In the Drawings

REMARKS:

FIG. 6

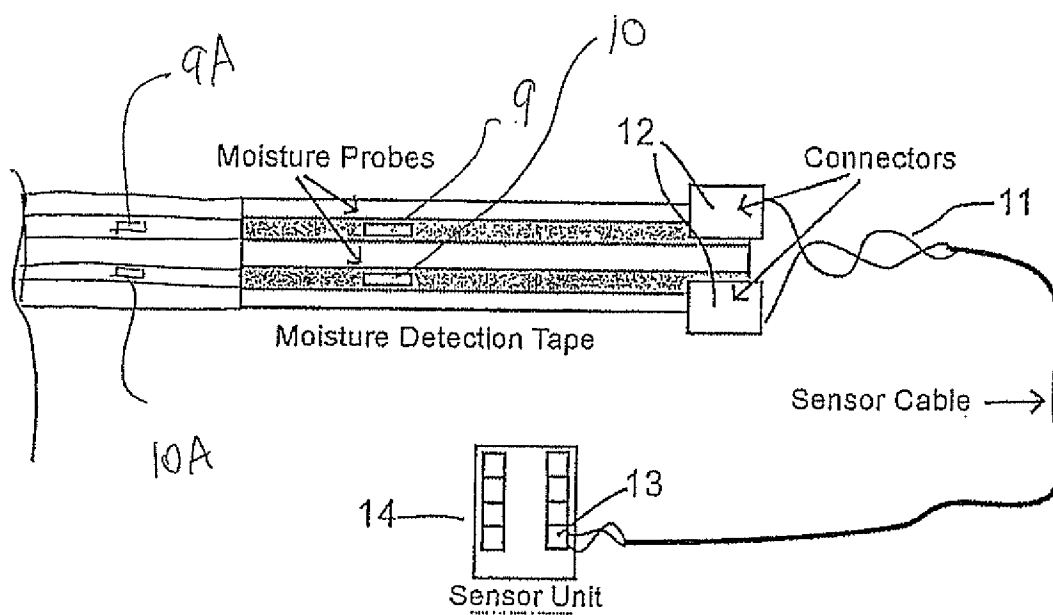
Replacement drawings of Figure 6 is enclosed herewith in which Figure 6 has been amended to show a second pair at a position spaced from the first pair and these are designated 9A and 10A. A copy of the original figure is enclosed for the Examiner's convenience.

In Figure 6 as filed, it is fully clear that the staples shown and referred to as "moisture probes" have a bridge portion extending along the conductor. It is absolutely clear that the element illustrated does NOT have any component bridging across the two conductors. The Examiner's interpretation of the specification cannot therefore be correct.

This construction is made clear in Figure 6 where the two conductors are shown. Also a single pair of "moisture probes" is shown. Thus each conductor is penetrated by a staple (probe) forming a respective one of the pair of probes with the bar or bridge of the staple running along the respective conductor so that each prong of the staple penetrates the SAME conductor.

While the Examiner has not objected that the claims include subject matter not illustrated, it is noted that the figures only show a single pair of moisture probes 9 and 10. Thus Figure 6 has been amended to show a second pair at a position spaced from the first pair and these are designated 9A and 10A. A minor amendment has been made in the description to refer to these reference numerals.
